PWROG-15060 Review Status

United States Nuclear Regulatory Commission (NRC)
Office of Nuclear Reactor Regulation (NRR)
Division of Safety Systems (DSS)
Reactor Systems Branch (SRXB)

July 14, 2016

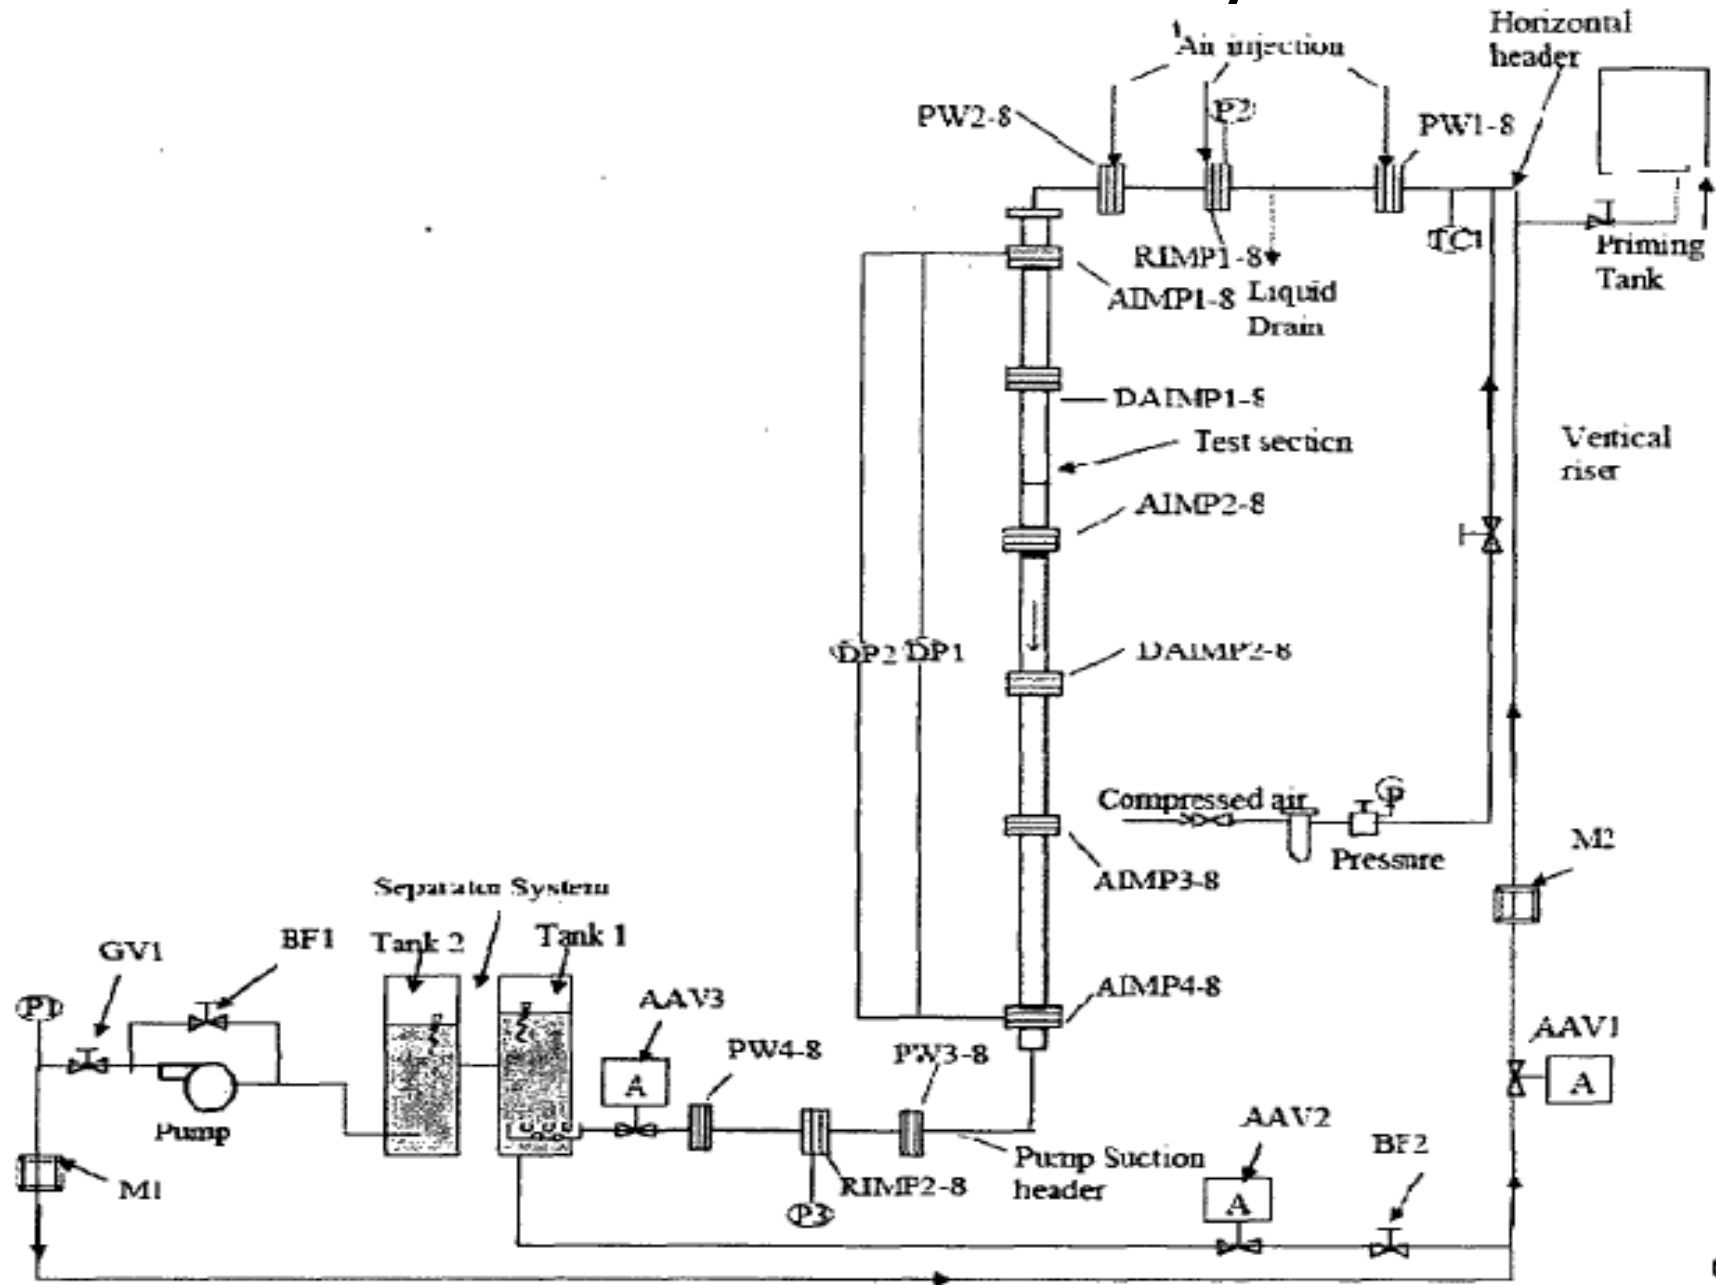
β exiting an elbow is obtained from:

Provide justification for using Equation 4-6 for the following:

- The upstream downcomer length is less than required to accommodate the ideal gas length that is calculated by PWROG-15060-P Equation 4-2.
- The upstream downcomer length is less than required to ensure that homogeneous bubbly flow occurs at the downcomer exit.
- The downcomer is located downstream of another downcomer and the connecting pipe is a short horizontal pipe where a kinematic shock does not occur.
- The downcomer is located downstream of another downcomer and the connecting pipe is a long horizontal pipe where a kinematic shock has occurred.
- The downcomer is located downstream of another downcomer and the connecting pipe provides homogeneous bubbly flow at the entrance of the downstream downcomer.

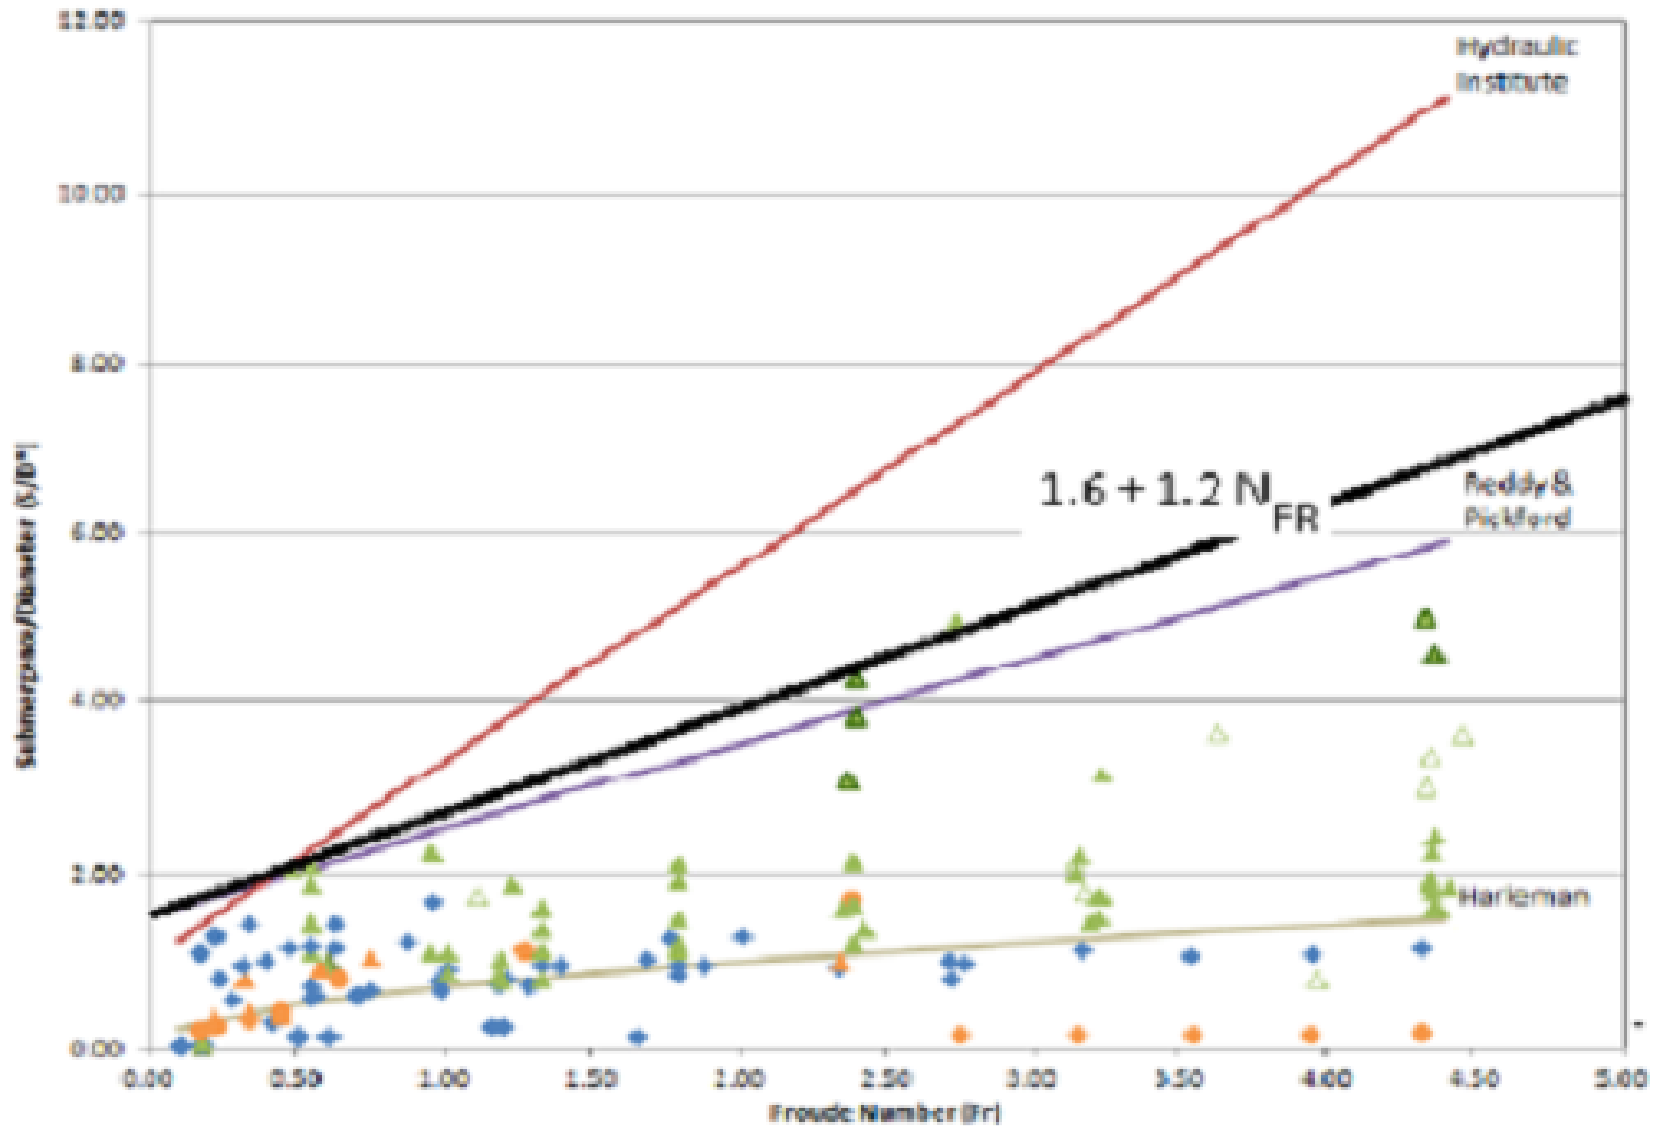
- Comparison of the PWROG-15060 correlations to Purdue data does not substantiate the predicted β values or trends. Review is not complete.
- Comparison of predicted downcomer length required to achieve homogeneous bubbly flow using Equation 5-6 is conservative when compared to Purdue data and is substantially less than required by the factor of four criterion.
